**MONTGOMERY COUNTY HISTORIC PRESERVATION COMMISSION**  
**STAFF REPORT**

<b>Address:</b>	13 Grafton Street, Chevy Chase	<b>Meeting Date:</b>	9/9/2020
<b>Resource:</b>	Contributing Resource Chevy Chase Village Historic District	<b>Report Date:</b>	9/2/2020
<b>Applicant:</b>	Norah & Diogo Coelho (Doug Mader, Architect)	<b>Public Notice:</b>	8/26/2020
<b>Review:</b>	Preliminary Consultation	<b>Staff:</b>	Dan Bruechert
<b>PROPOSAL:</b>	Porch Alterations, Building Addition

Design Development  
Roof Plan

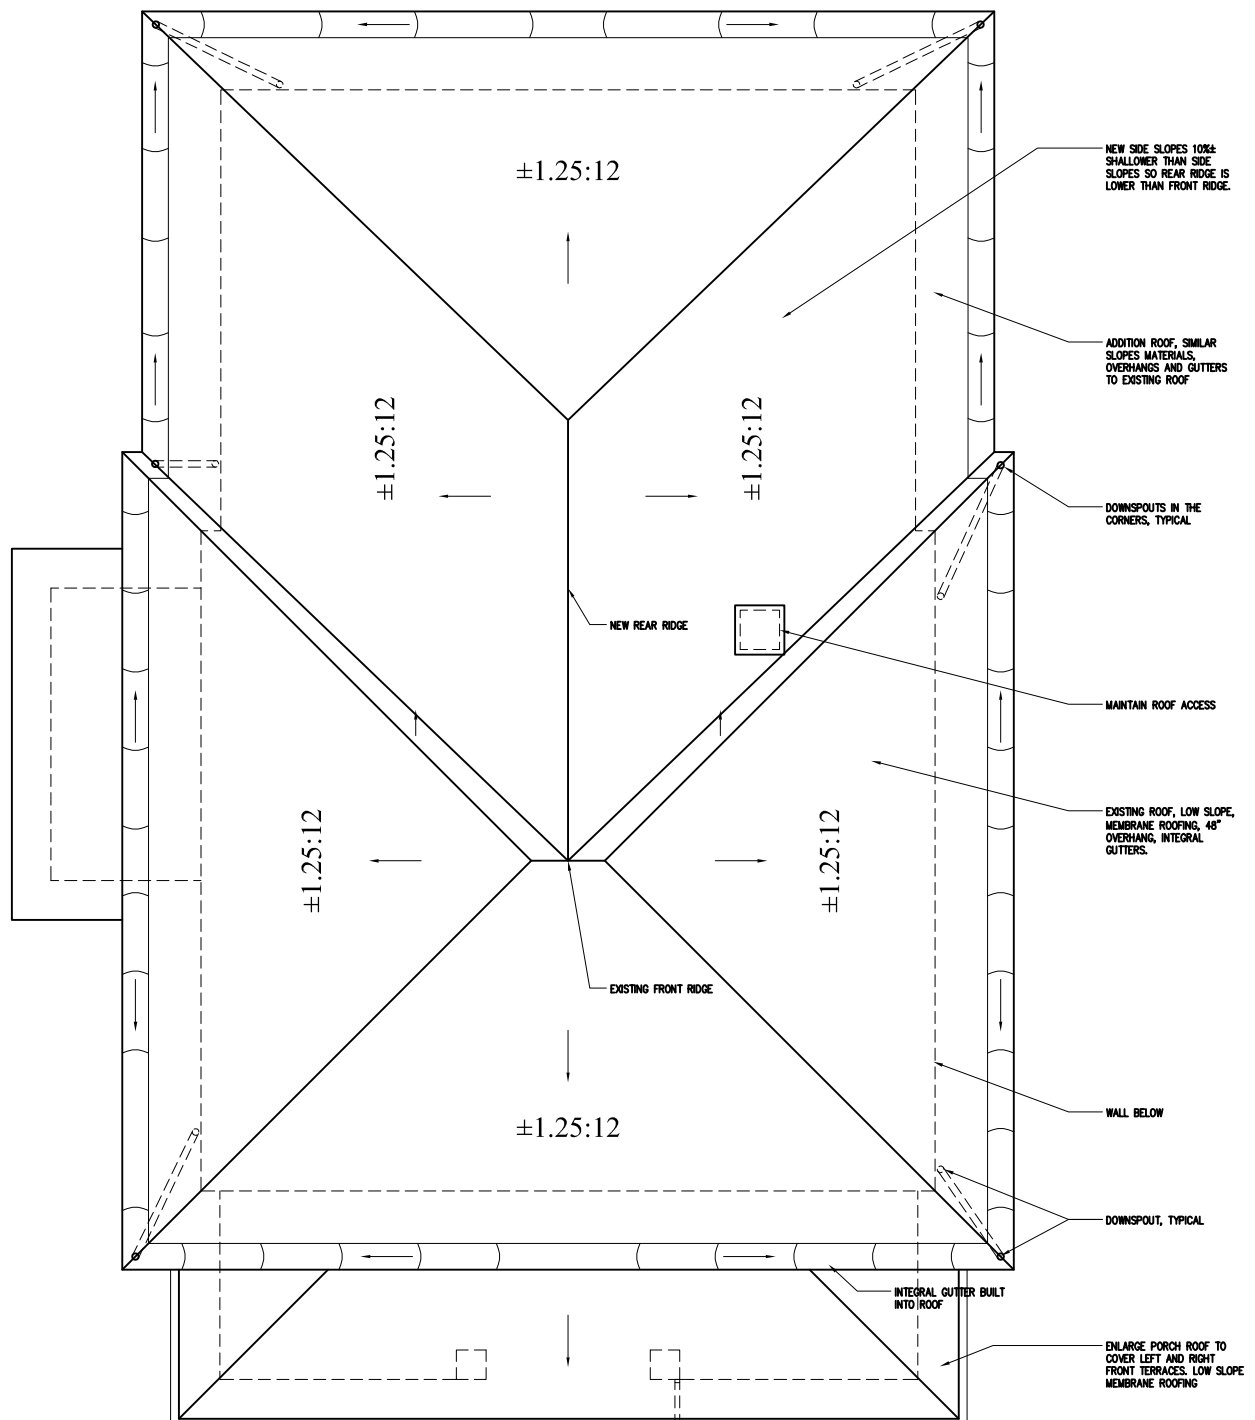
Finally, Staff notes that the notations on the proposed roof plan are not what is shown in the drawings and that the discrepancy needs to be resolved in a HAWP submission.
